A REVIEW OF BWR/6 STANDARD PLANT
PROBABILISTIC RISK ASSESSMENT:
VOL. 1: INTERNAL EVENTS, CORE DAMAGE FREQUENCY

N. A. HANAN, K. K. SHIU, R. KAROL,
E. ANAVIM, I. A. PAPAZOGLU

DEPARTMENT OF NUCLEAR ENERGY, BROOKHAVEN NATIONAL LABORATORY
UPTON, NEW YORK 11973

PREPARED FOR
U.S. NUCLEAR REGULATORY COMMISSION
WASHINGTON, D.C. 20555

Figure C.1 BNL revised containment event tree for class 2 type accident sequences.

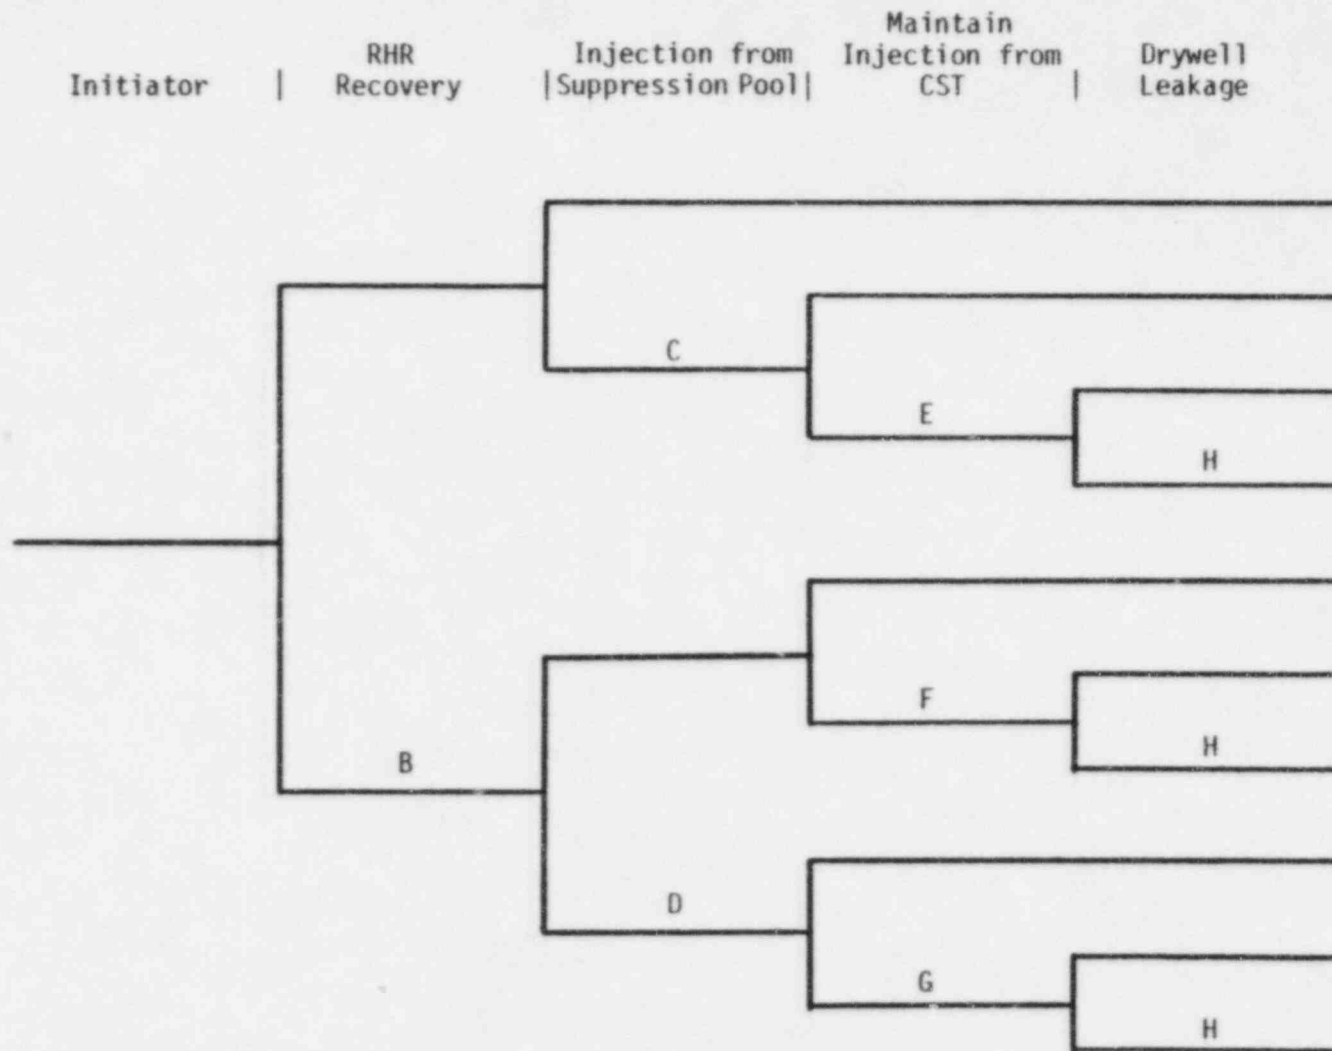
Function	Initiator	Probability	Branch in ET	Description/Comment
RHR Recovery	T_E • Class CT2T	1.0	B	d) A sequence accounting for about 21% of the Class CT2T for a LOOP initiator (the 6th sequence in Figure 4.11) is very similar to the one in item c) above; the only difference is that there is a common mode failure of the batteries instead of two DGs.
	T_E • Class CT2T	0.85	B	e) For all the other LOOP sequences the same comment as in item a) applies.
	T_{DC} • Class CT2T	1.0	B	f) Since for 85% of the Class CT2T for a T_{DC} the recovery of DC power (Divisions 1 and 2) and initiation of RHR without DC power is included in the first stage (for 24 hrs) no credit was given for the time interval between 24 and 27 hrs.
	A • Class CT2L	0.24	B	g) Same as item a). However, since no credit for RHR recovery was given in the first stage, the probability of recovery in 27 hrs is given by: $\exp(-27/19) = 0.24$
